SUBJECT: Site Plan Review for 750 West Streetsboro Street - Parking Expansion for Christ Community Chapel

PC Case No: 2016-15

RE: PC 2016-15 - Site Plan review for Hudson Community Chapel

**Re:** **Christ Community Chapel – Parking Lot Expansion**

**C100**

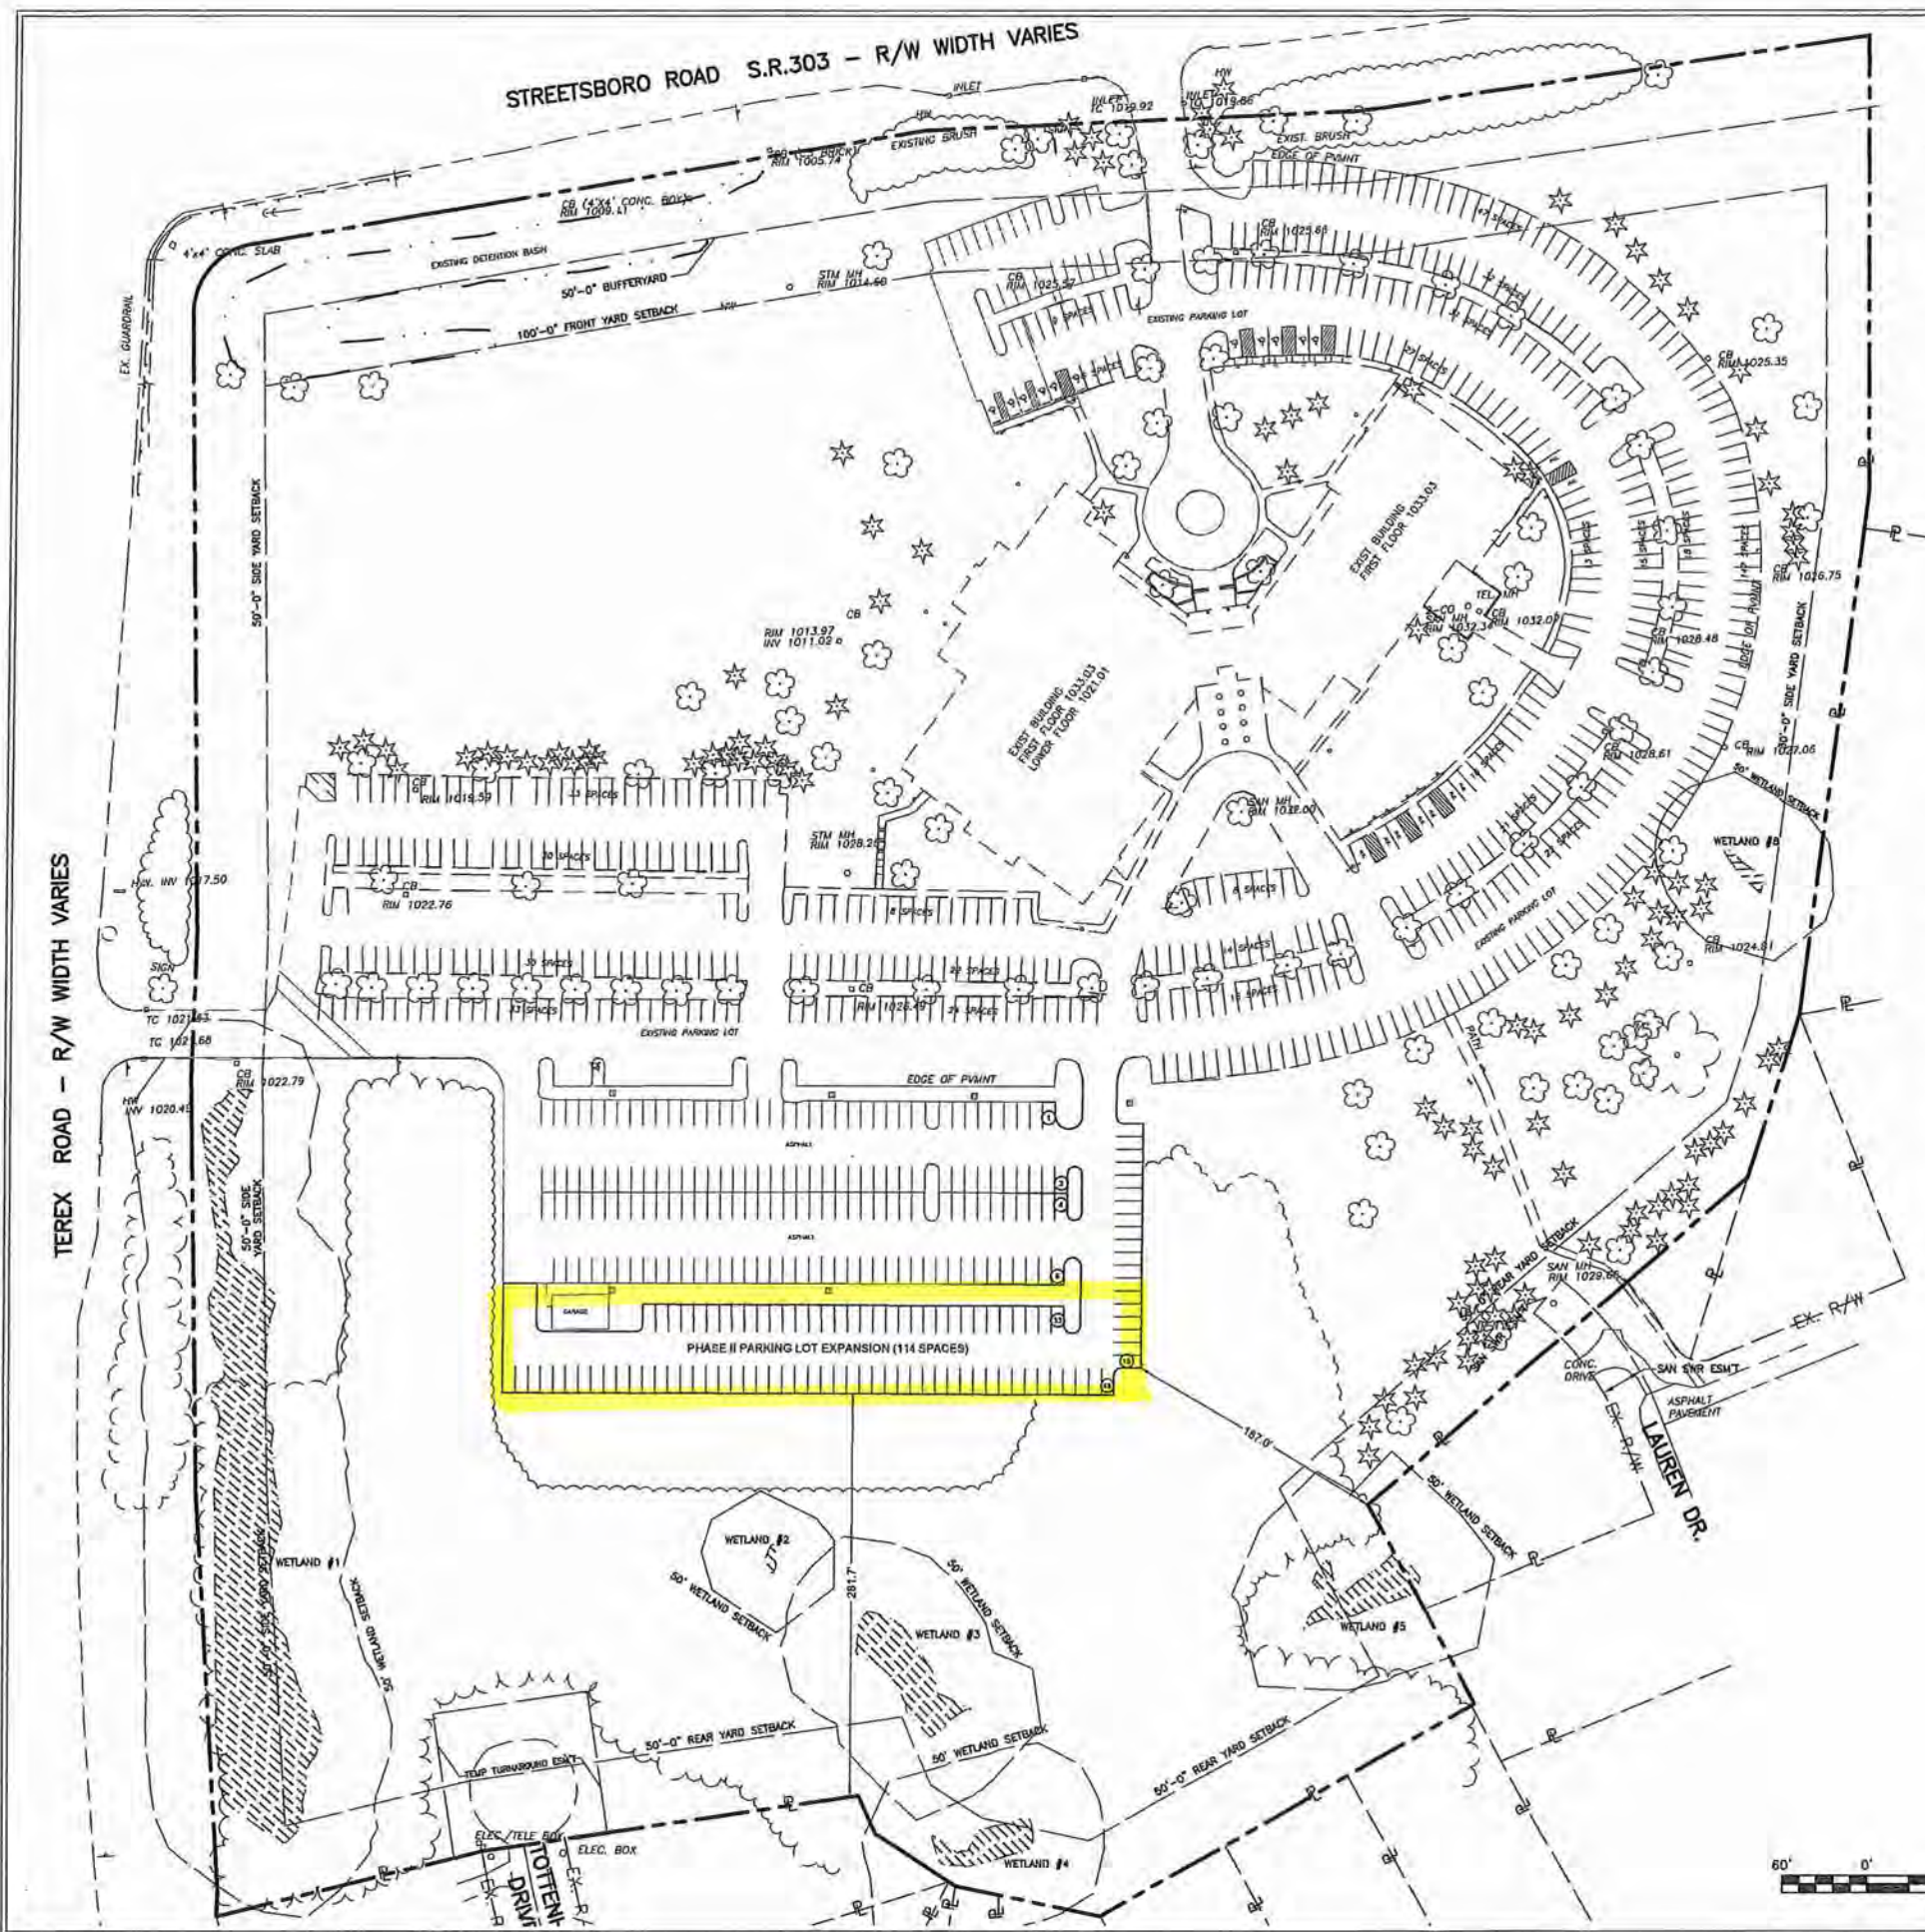
1. An overall view of the site must be added to the plans to depict the project area in relation to the full site and the setback from adjacent property lines.

1. Submit an updated wetland delineation for the project area or documentation from Floyd Brown Group that the previously delineated areas have not changed. Additionally the wetland areas south of the parking improvements from the 2005 delineation must be added to the plans.

2. Revise the landscape plan to incorporate interior island plantings adjacent to the shed. All interior landscaping areas must be revised to incorporate shade trees and plantings/ground covers.
3. Indicate the existing and proposed parking count for the facility.
4. Incorporate an overall view of the site must be added to the plans to depict the project area in relation to the full site and the setback of the from adjacent property lines.

**C402**

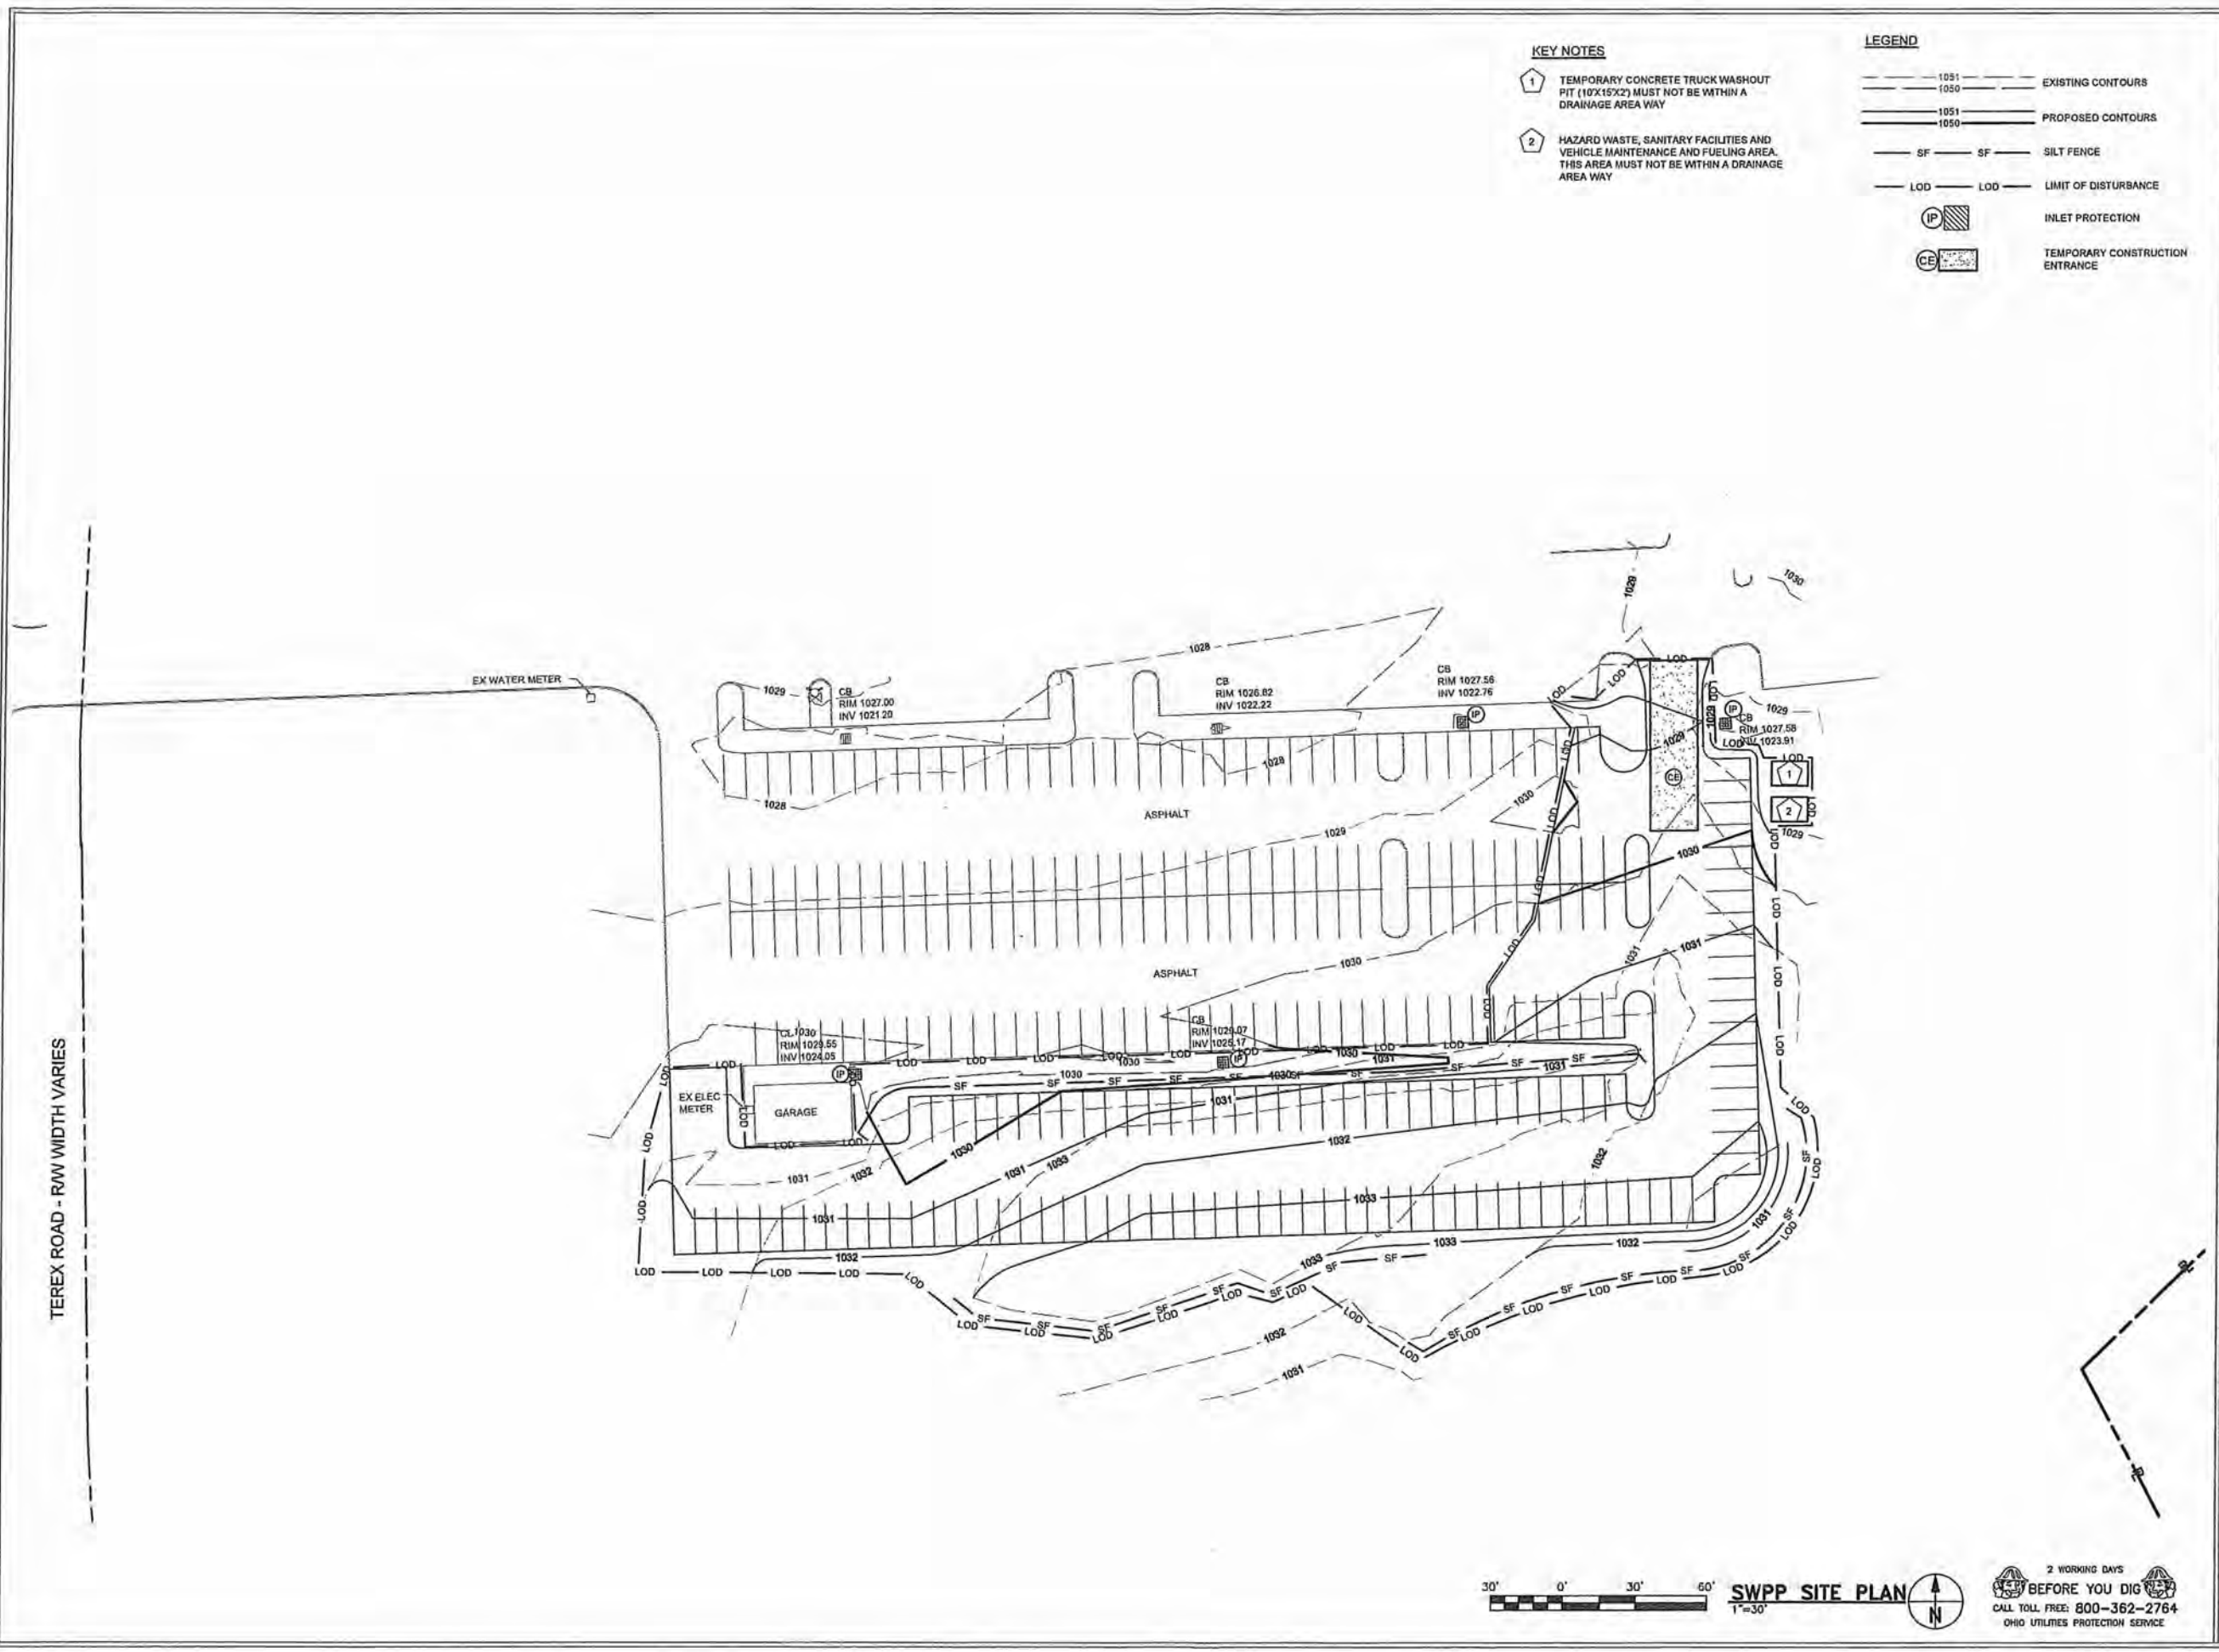
1. Provide the total area of disturbance for this site and show on the grading plan a 'line' for the limits in order for our inspector during construction. This includes any stockpiled material or other areas disturbed during construction around the perimeter of the proposed parking area. A submittal to Summit Soil and Water and Notice of Intent to the OEPA may be necessary if the site exceeds 1 acre.

3. Note, based on item #1 and if a SWPPP needs to be submitted for this site, a minimum of silt fence and inlet protection shall be properly shown with details on installation for this site.
